**Subject:** San Mateo Park Elementary School HVAC Replacement  
San Mateo - Foster City School District  
Aedis Project No. 2021011.08  
DSA Application #01-120214

### ADDENDUM NO. 1

San Mateo Park Elementary School HVAC Replacement  
San Mateo – Foster City School District  
Aedis Project No. 2021011.08

3 PACKAGED AC UNIT CONTROL SCHEMATIC

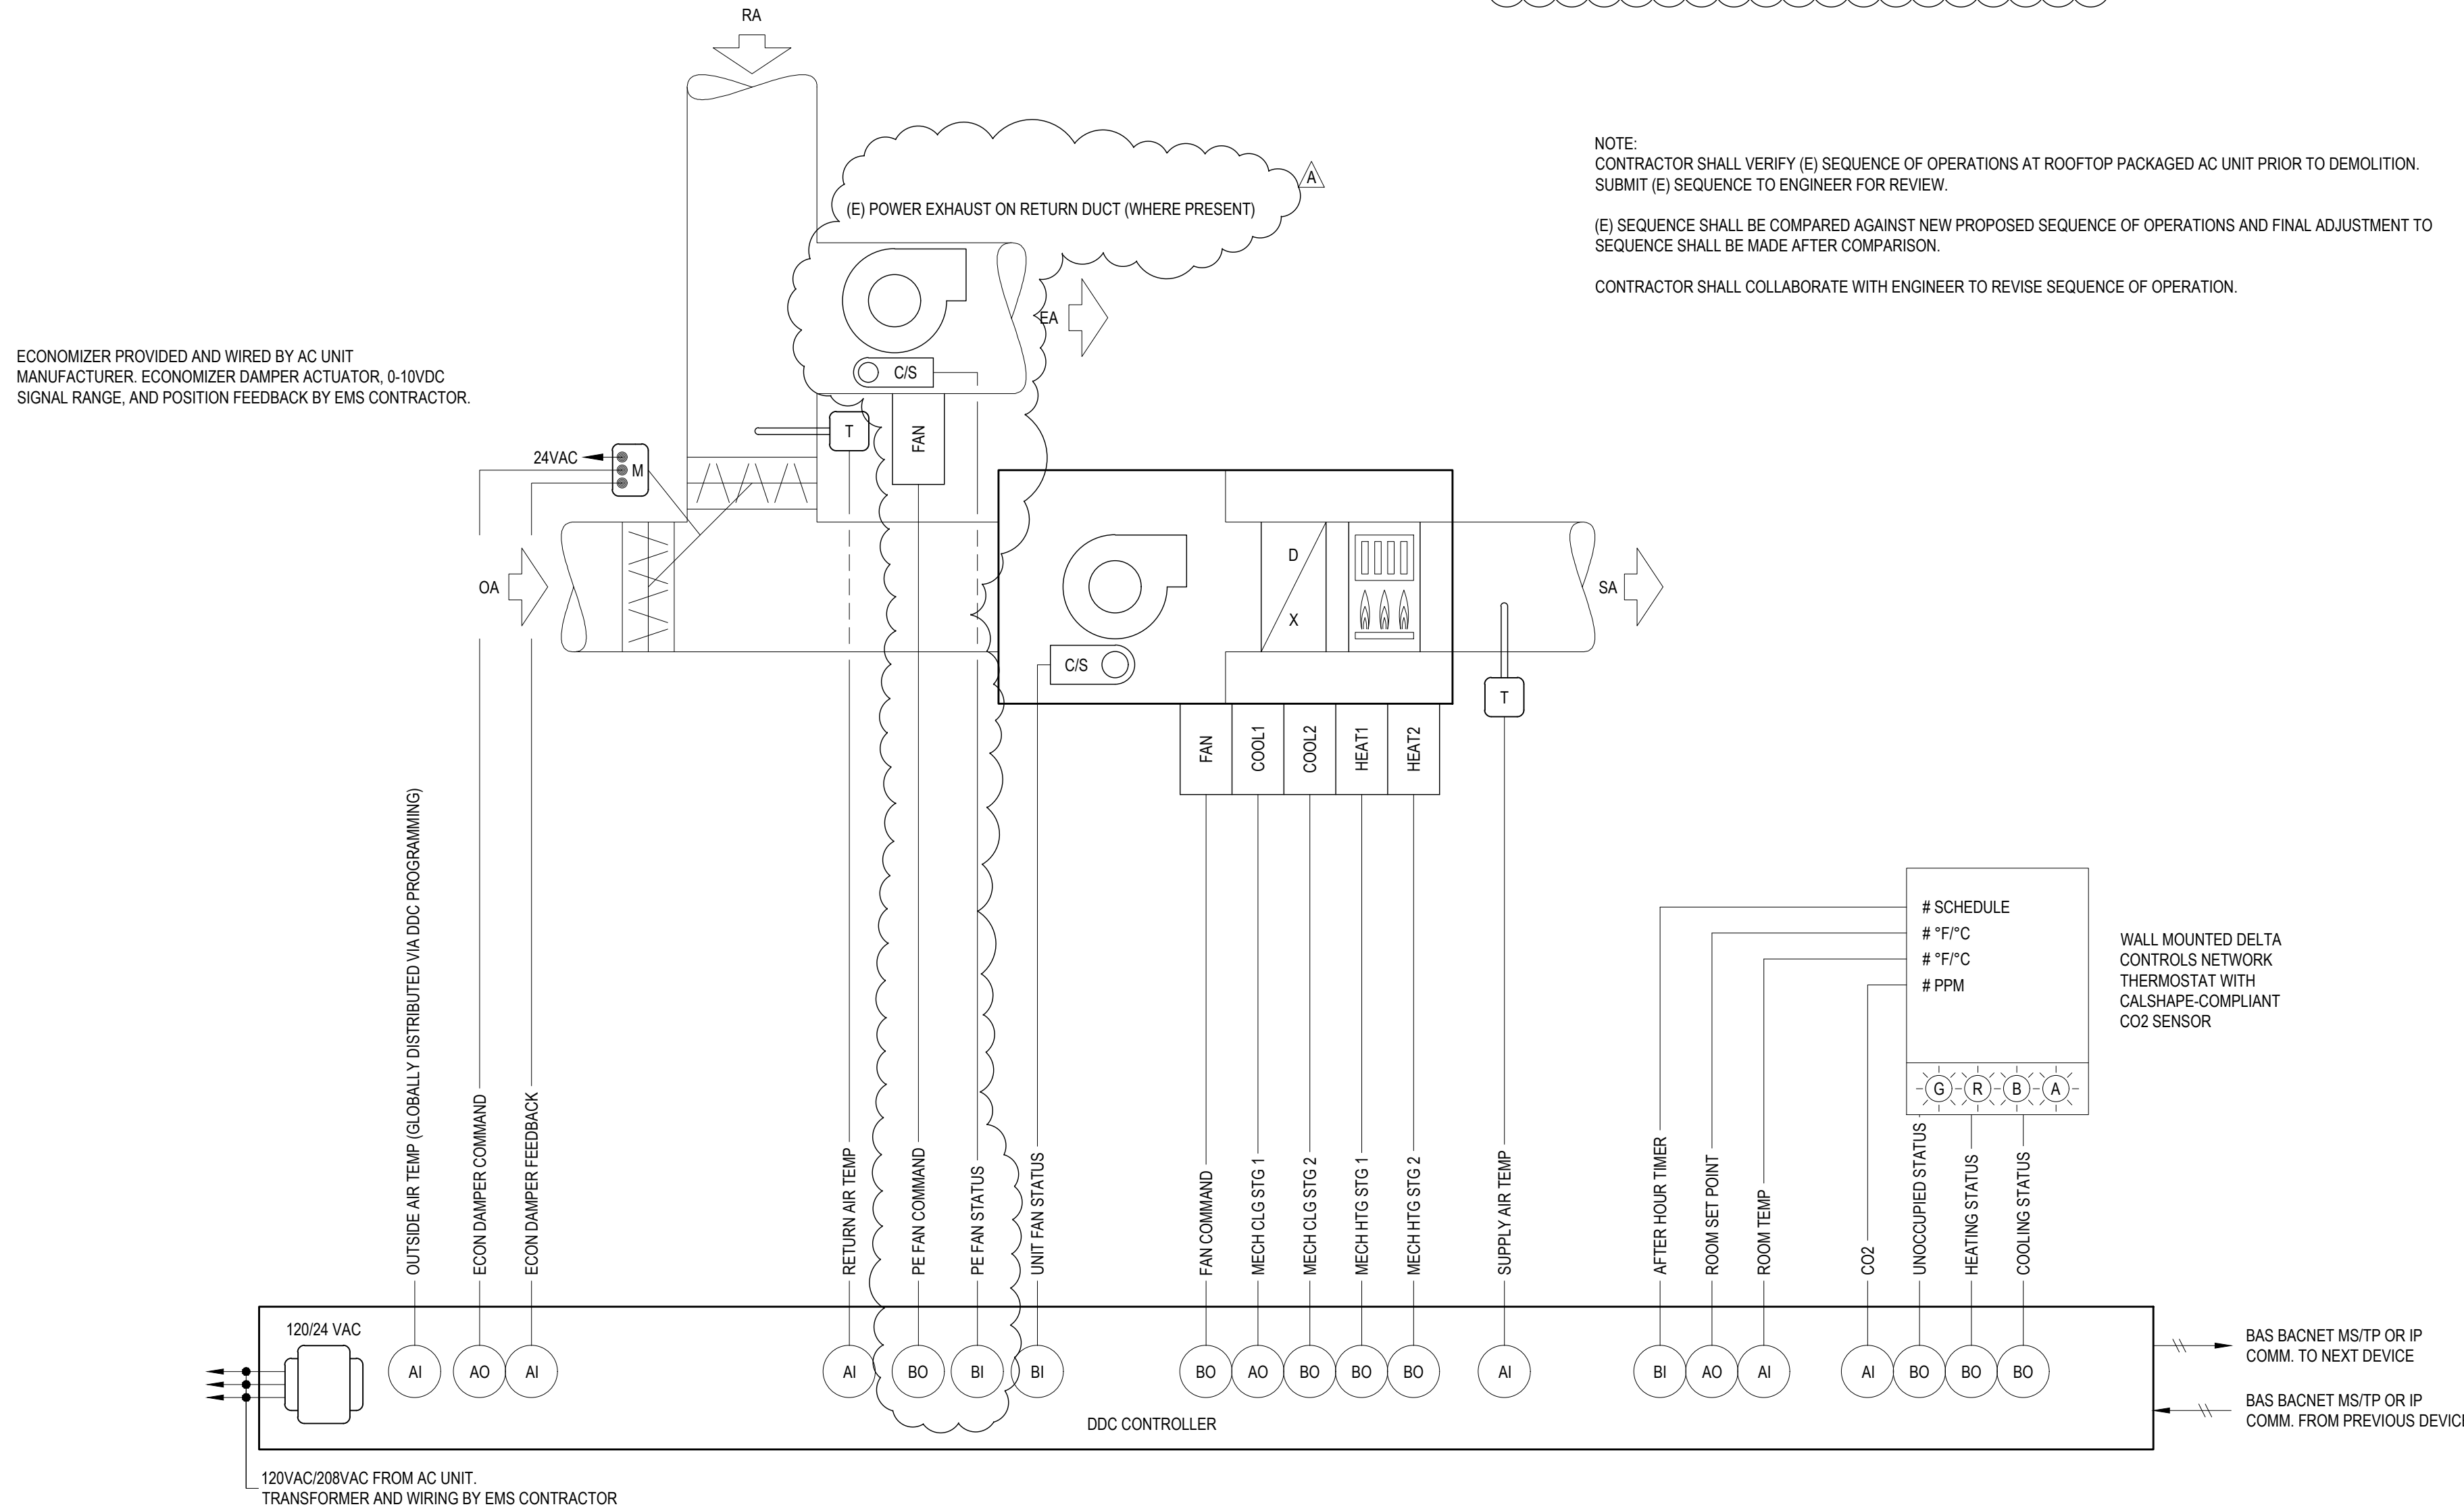
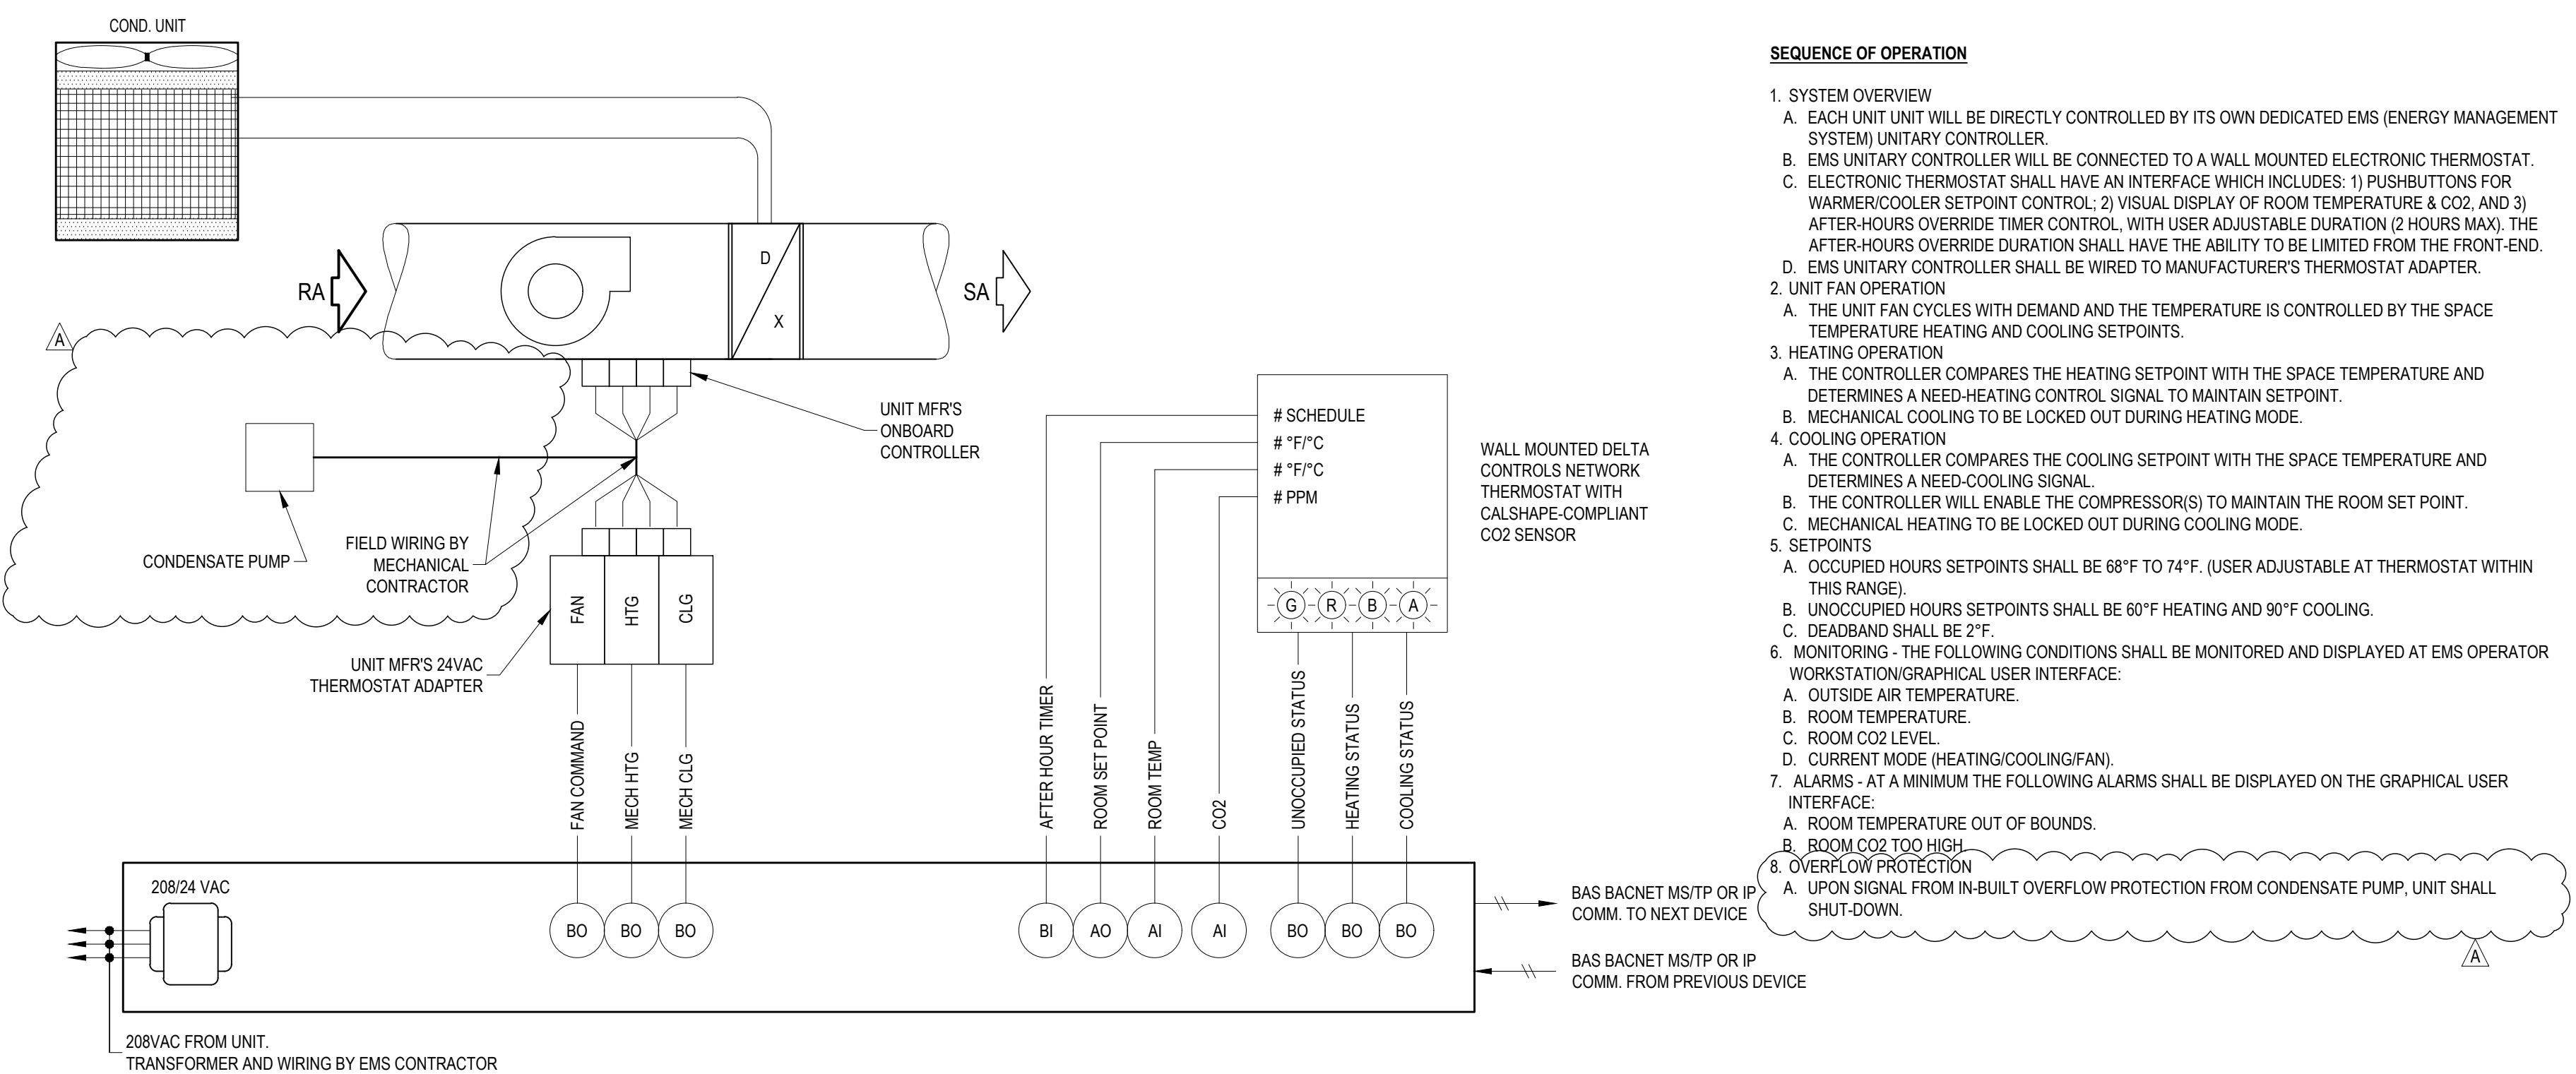
Add: New notes to EMS System Architecture as shown per AD1-MP5.01

Revise: Sequence of operation numbering at Classroom Split System Heat Pump/Fan Coil Unit Control Schematic as shown per AD1-MP5.01

Add: Sequence of operation note #12 and wiring for condensate pump overflow protection to Classroom Split System Heat Pump/Fan Coil Unit Control Schematic as shown per AD1-MP5.01

Add: Sequence of operation note #8 and wiring for condensate pump overflow protection to Wall Mount Split System Control Schematic as shown per AD1-MP5.01

Add: Packaged AC Unit Control Schematic Note #14 and wiring for power exhaust as shown per AD1-MP5.01

Revise: Packaged AC Unit Control Schematic Notes #8 & #9 as shown per AD1-MP5.01
